APPENDIX B MITIGATION MONITORING, COMPLIANCE, AND REPORTING PROGRAM REQUESTS AND AUTHORIZATIONS

PUBLIC UTILITIES COMMISSION

Subject: Salt Creek Substation—Review of Minor Project Refinement Request #1

SDG&E's Proposed Minor Project Refinement #1

ATTACHMENT 1 SDG&E Minor Project Refinement Request for Change in Limits of Disturbance Figure

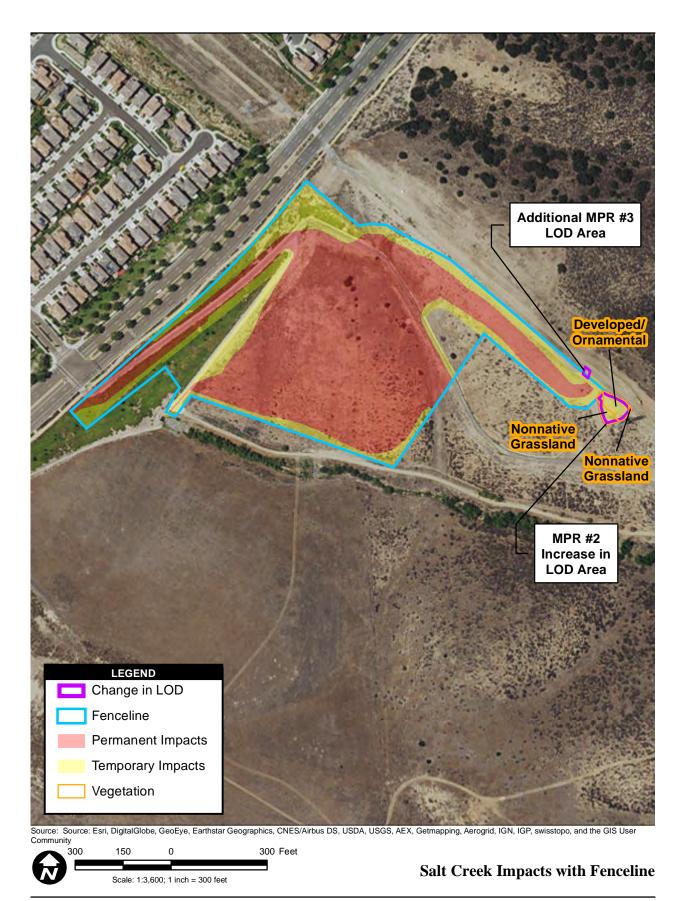
SDG&E's design team is requesting a change to the previously identified Limits of Disturbance (LOD). Specifically, this MPR Request #2 is for a change of the LOD in the east portion of the project area to allow for additional parking. The requested approval date of this MPR Request #2 is September 3, 2016. The change in LOD would increase the substation work area by approximately 0.13 acres. The new total impact area would be 13.24 acres. This increase in LOD would allow for additional parking closer to the substation perimeter gate, once the Hunte Parkway parking is inaccessible during the construction of the access road to Hunte Parkway. The anticipated start date of using this increase in LOD would be is September 3, 2016.

The attached figure (Attachment 1) and images (Attachment 2) show the new temporary disturbance area. The purple line in the southeast corner surrounding an area of yellow notes the approximate change in LOD.

ATTACHMENT 1 – Change in LOD Figure

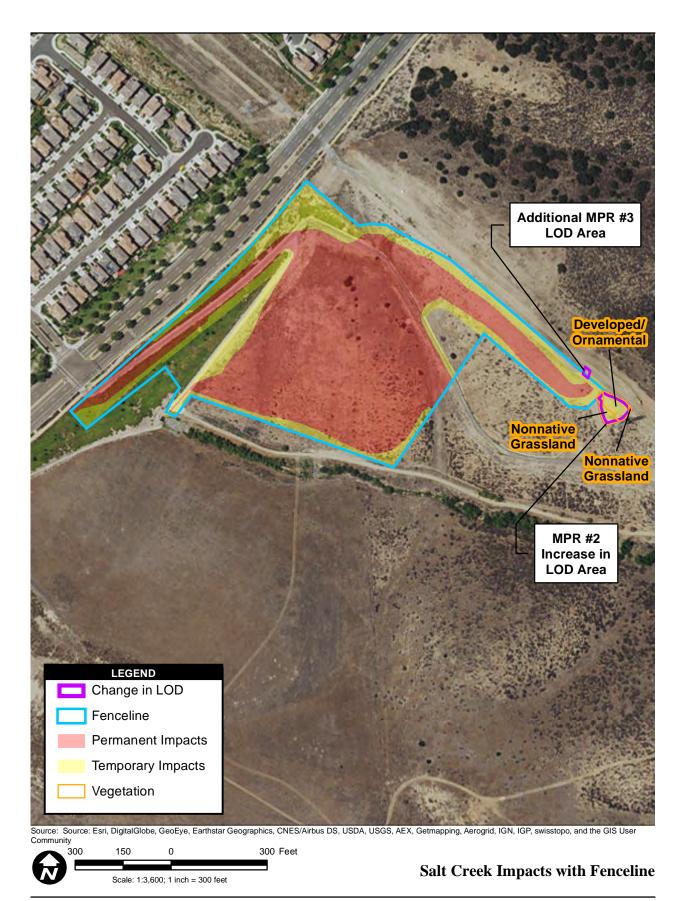
SDG&E's design team is requesting a change to the previously identified Limits of Disturbance (LOD). Specifically, this MPR Request #3 is for a change of the LOD in the east portion of the project area to allow for transportation between the SDG&E access road and the San Diego County Water Authority access road (SDCWA) during the import of soil. The requested approval date of this MPR Request #3 is August 22, 2016. The change in LOD would increase the substation work area approximately 450 square feet (sq. ft.) (0.01 acre). The new total impact area would be 13.29 acres. This increase in LOD would be bladed and graded to allow trucks that are dropping off imported soil to turn from the SDG&E access road onto the SDCWA access road. Due to the high frequency of trucks arriving from the SDG&E access road (twelve trucks per hour) it is necessary that there is a safe location for the trucks to turn onto the SDCWA access road.

This area is within the biological study area analyzed in the Biological Technical Report and was mapped as non-native grassland and lies just south of the NCCP area. Temporary impacts to 450 sq. ft. would occur as a result of this increase in LOD. This area was surveyed by a biologist and was determined to be dominated by San Diego sunflower. Approximately 97 individuals of San Diego sunflower would be impacted and would therefore be added into the Special Status Plants Mitigation and Monitoring Plan. The 450 sq. ft. of temporarily impacted non-native grassland habitat that would occur as a result of this increase in LOD would be hydroseeded in accordance with the requirements of the Salt Creek Substation Project Restoration and Enhancement Plan for Temporary Impacts.

The attached figure (Attachment 1) shows the new temporary disturbance area. The purple line in the northeast corner surrounding an area of yellow notes the approximate change in LOD.

Figure 3-5: Salt Creek Substation Layout

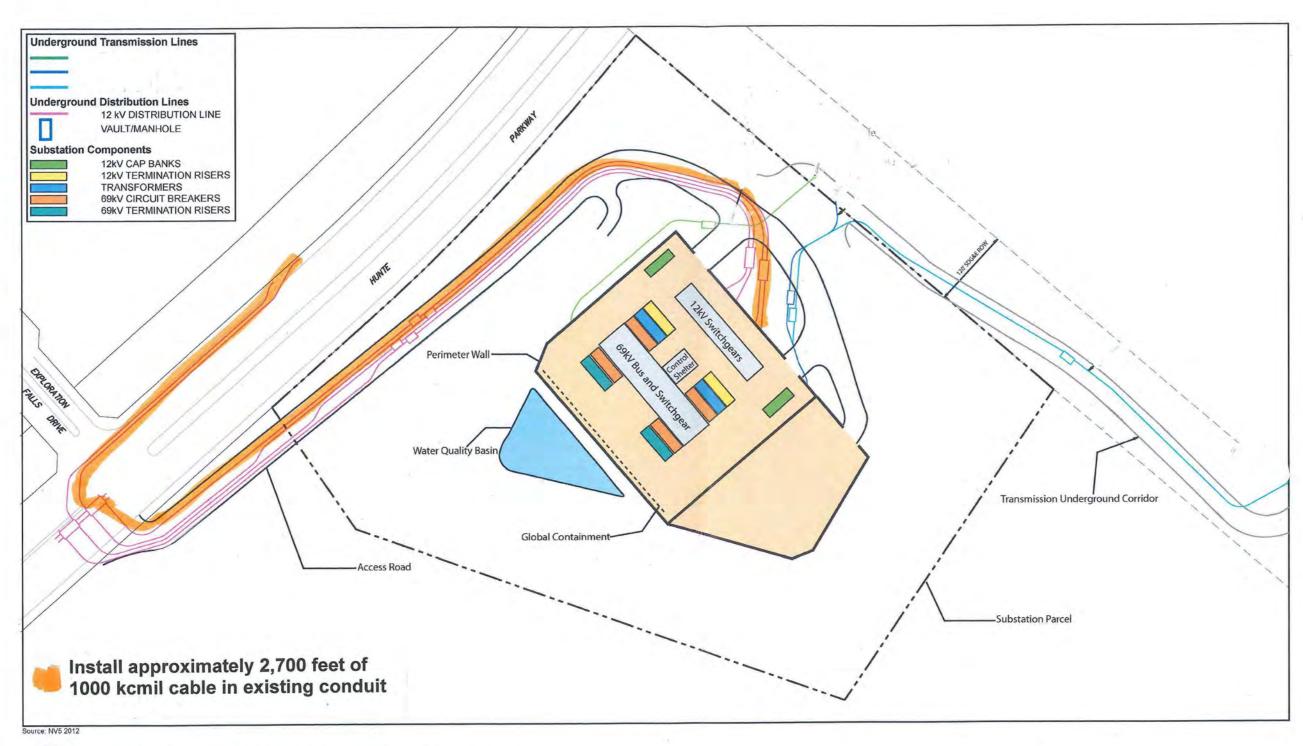
SDG&E's design team is submitting this MPR #4 as notification of an electrical design change from what was included in the Salt Creek Proponents Environmental Assessment (PEA). The PEA identified three circuits with the possibility of 13 additional circuits that could be installed based on load demands. This MPR Request #4 is for the addition of a fourth circuit to the previously proposed three circuits. This additional fourth circuit will avoid overloading one of the approved circuits.

We have reviewed SDG&E's request for MPR #4. We have also reviewed the project description in the Final EIR. The Final EIR described that the project would include up to 16 distribution circuits at build-out. The analysis in the EIR accounts for up to 16 distribution circuits. The addition of a fourth distribution circuit at this time is therefore not a modification or refinement of the project, but is part of the project that was evaluated in the Final EIR. No minor project refinement is required to proceed with this action because it is part of the CPUC approved project.
